Design Review Committee
April 11, 2013

SUBJECT: **Case 18404: Substantive Site Plan Approval – Addition to Scotia Square, Barrington Street, Halifax**

SCOTIA SQUARE - BARRINGTON EXPANSION

HRM SUBSTANTIVE SITE PLAN APPROVAL APPLICATION: SUPPORTING DOCUMENTS

Approval Plans

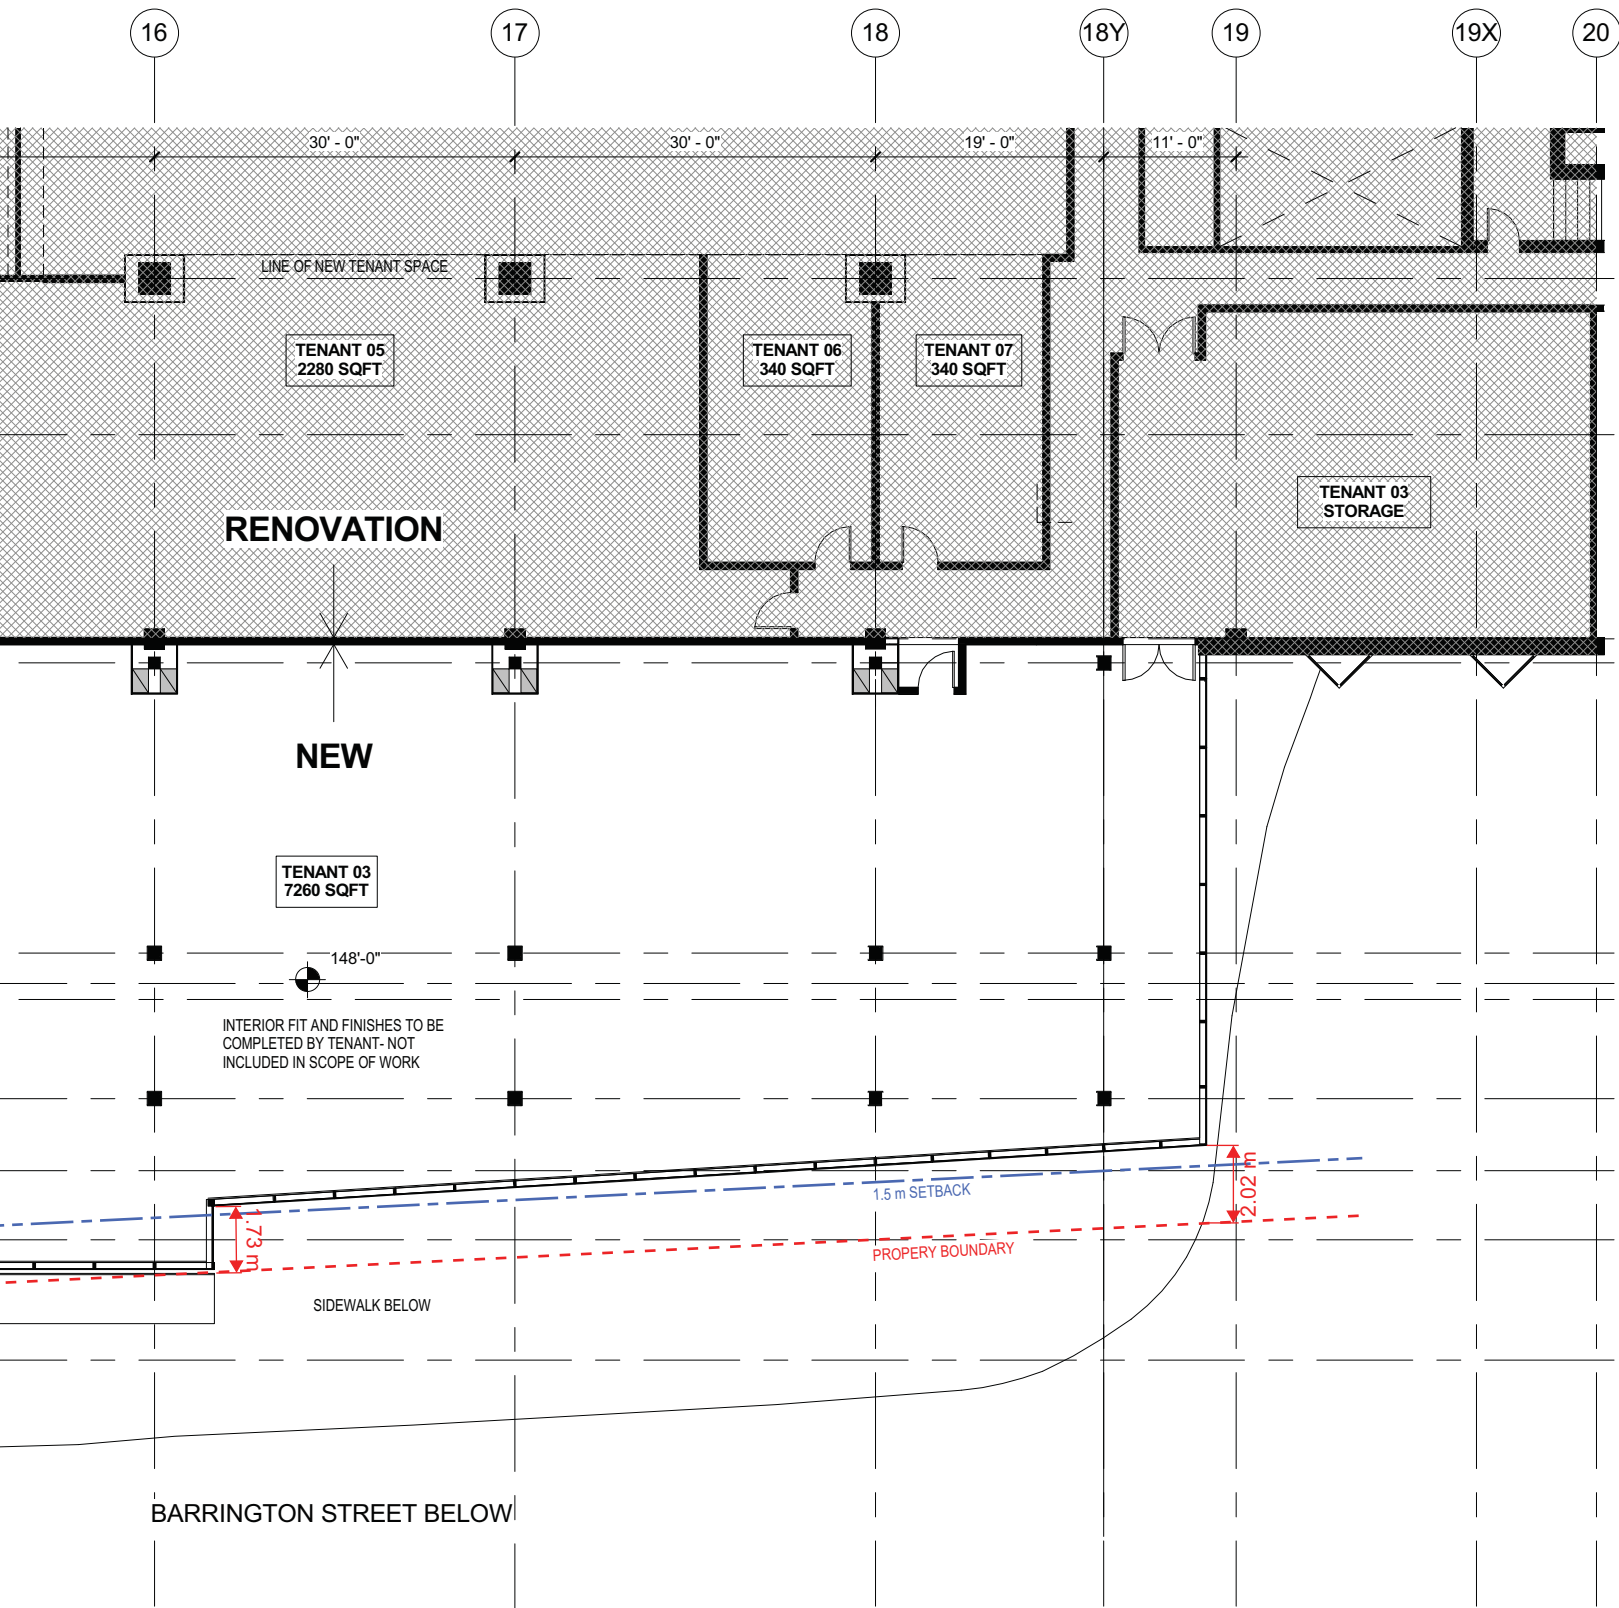
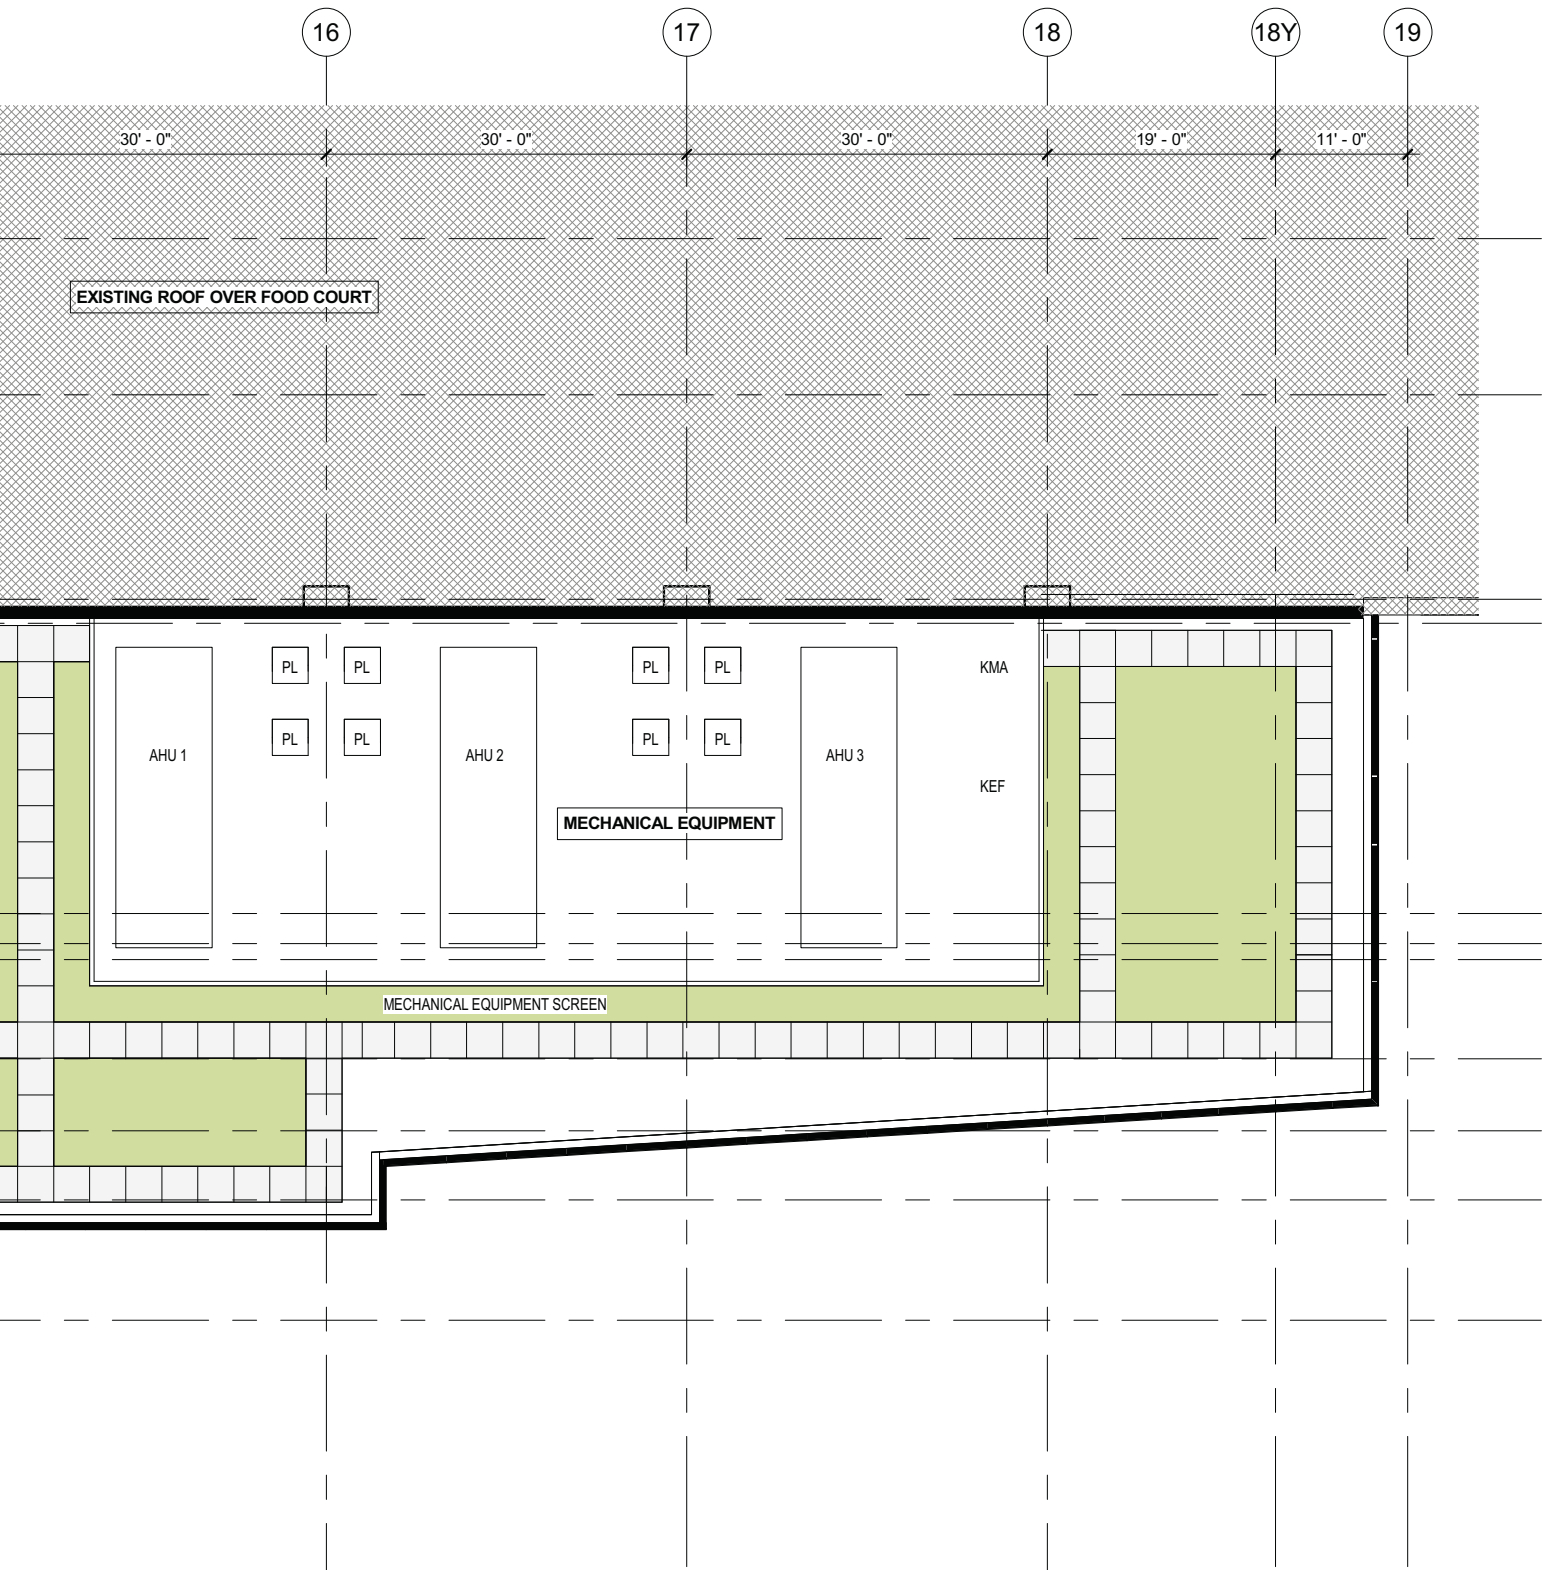
The proposed building addition will be located closer to Barrington Street than the existing structure, but will not meet the maximum permitted 1.5 metre streetwall setback. As such, a variance of the maximum streetwall setback will be required.

There is one variance being sought to the quantitative elements of the LUB for this development, relative to the maximum streetwall setback from Barrington Street. The required setback pursuant to the LUB is between 0 and 1.5 metres. The Barrington Street right of way shifts slightly westward in this location (refer to Attachment A). The existing building setback ranges between 10 and 16 metres from the Barrington Street property line. The proposed addition will be located closer to the street, resulting in a setback of between approximately 0 and 4 metres, which is a significant improvement. The variance request is relatively minor and reasonable, given the improvement in the streetwall location which is achieved.

1. Approve the qualitative elements of the substantive site plan approval application for a 3-storey addition to the Scotia Square complex on Barrington Street, Halifax, as shown on Attachment A; and
2. Approve the requested streetwall setback variance along Barrington Street as shown on Attachment A.
